# Detention Pond Impact on Remaining Walnut Trees

Village of Downers Grove  
Plan Commission Hearing  
File PC-25-05  
October 3, 2005

William McCune  
1436 Thornwood Drive

Looking WEST from Carpenter Street

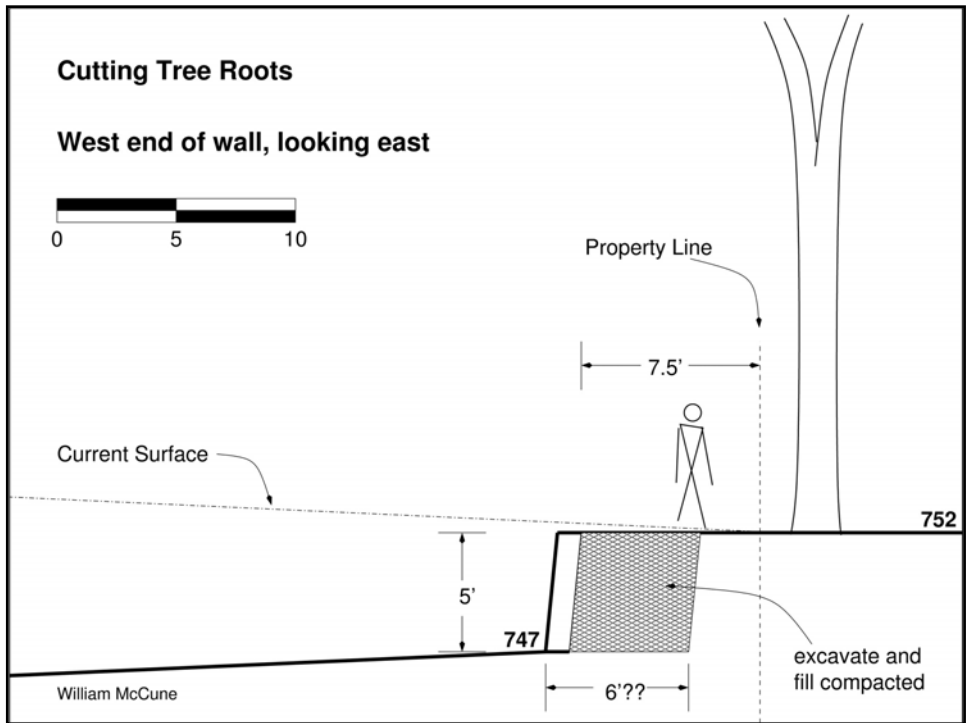
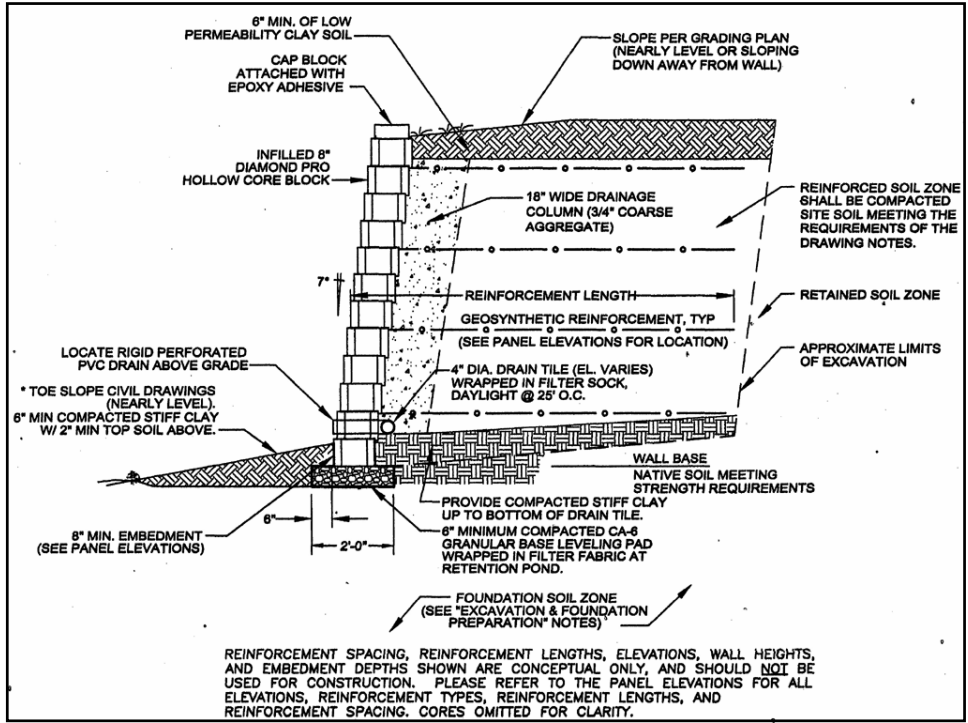
### Suffocation of Tree Roots

- We ask the Plan Commission to prohibit any construction activity within the standard Critical Root Zone.
- One foot of radius for each inch of trunk diameter.
